**Advisory Action
Before the Filing of an Appeal Brief**

Advisory Action Before the Filing of an Appeal Brief	Application No.	Applicant(s)
	10/538,082	MOGCK ET AL.
Examiner	Art Unit	
Erica E. Cadogan	3722

APPLICANT: Gerhard MOGCK ET AL. - 1
SERIAL NO.: 10/538,082 Examiner: E. E. CADUGAN
FILED: October 17, 2005 Group: 3722
TITLE: DEVICE FOR ASSEMBLING, TUNING, AND ...
REPLACEMENT SHEET

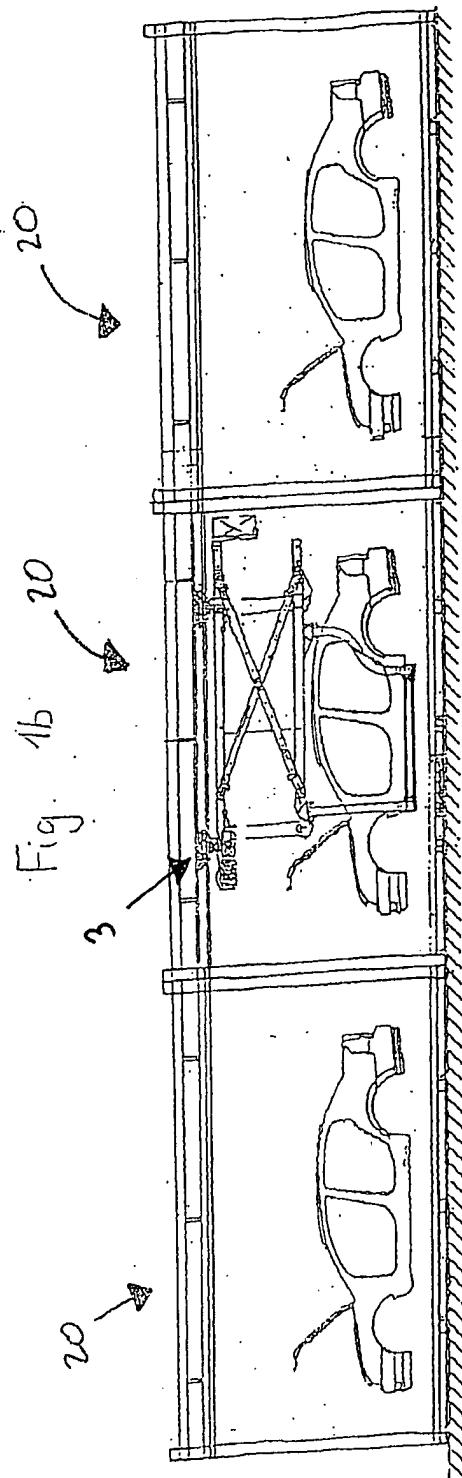
Secondly, it is noted that the proposed reply introduces new matter in at least some of the drawing amendments. For example, in amended Figure 1b, the specification as originally filed does not teach that each of the elements now labeled as 20 are "assembly units", noting that the specification as originally filed also teaches the use of testing and rework units, and thus, for at least this reasoning, it is not inherent that each of the units labeled as 20 in amended Figure 1b are "assembly units" (as also inserted by amendment into the specification on pages 6-7 in the amendment of 12/14/07). Additionally, the amendment to Figure 4 of 12/14/07 includes new matter, noting that the specification as originally filed does not support such a showing of an "assembly hall". For example, it is noted that the specification as originally filed does not teach that the "assembly hall" is located as shown or includes the particular stations shown.

Not
Approved
1/15/08

As a side note: the proposed Figures 1b and 4 are not approved (in light of the new matter issues mentioned previously) and the proposed Figures 2b, 3b, 3c, 5a-5d are approved.

Fig. 2b

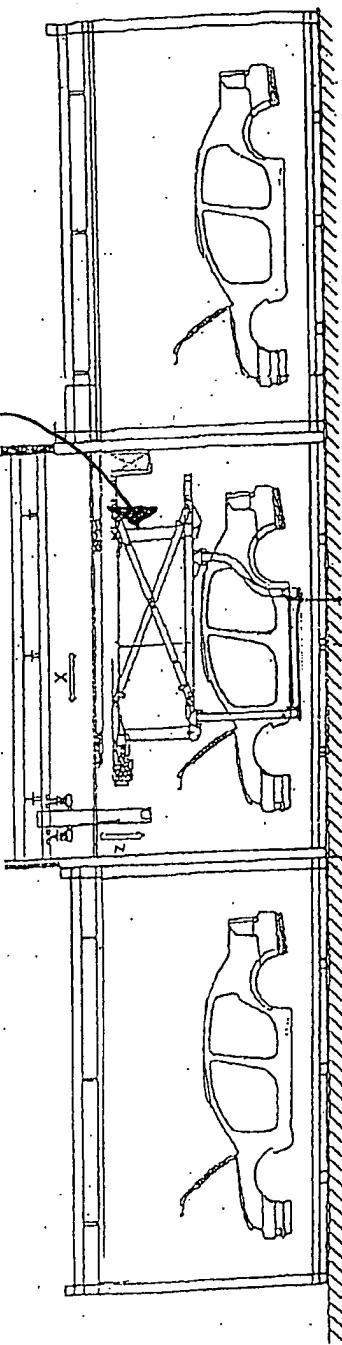
Approved
EAC
11/16/08

Fig. 3b

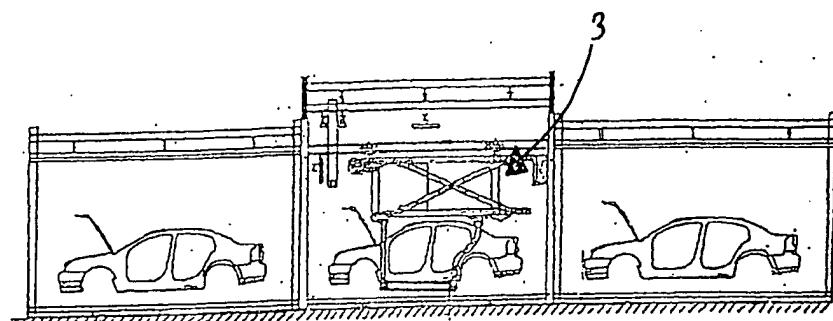
Approved
ECC
1/16/08

Fig. 4

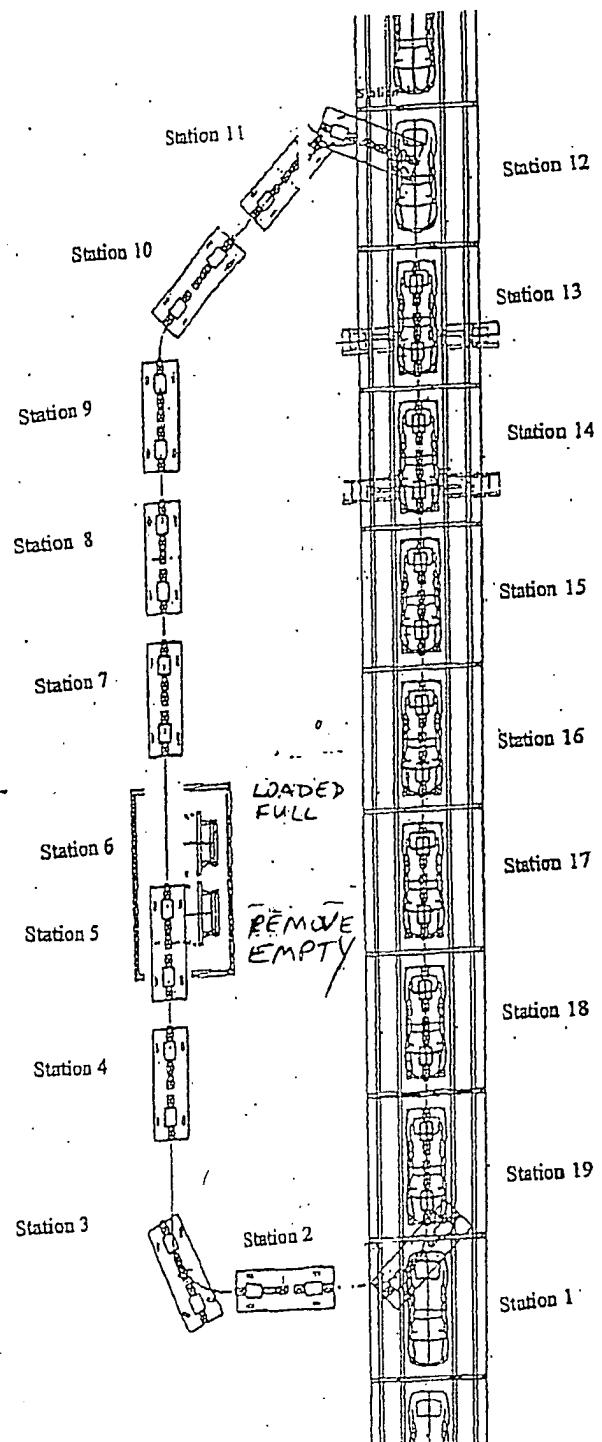
22
Not
approved
EEC
1/16/08

Fig. 5b

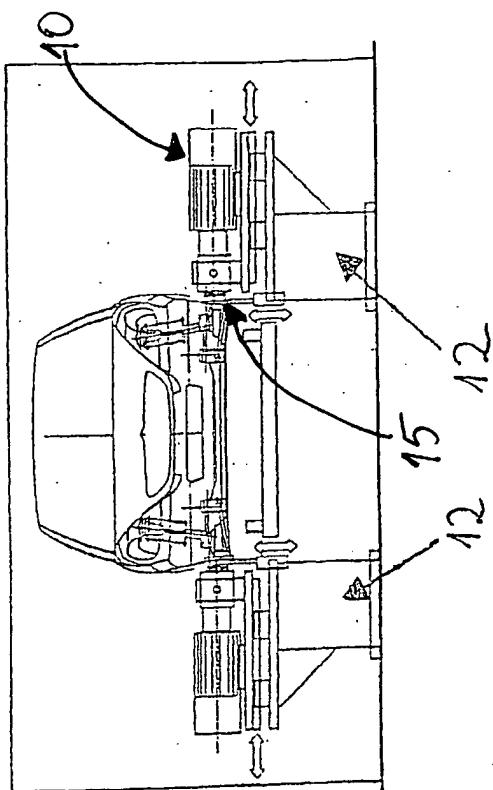
Approved
ECC
1/16/08

Fig. 5c

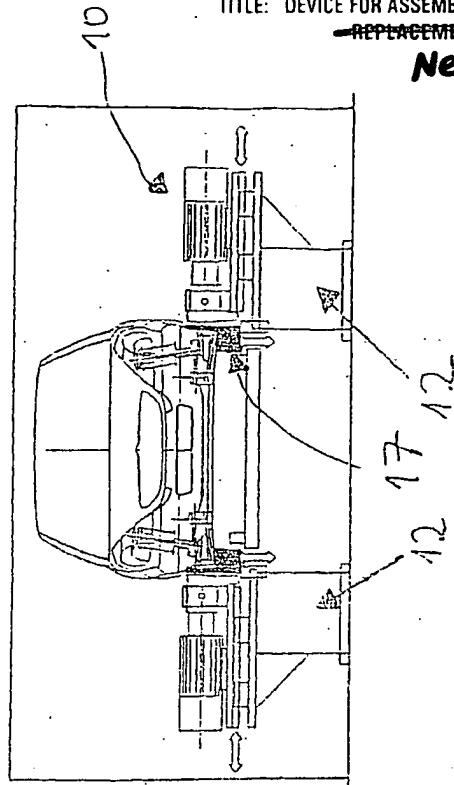
Approved
EEC
11/16/08
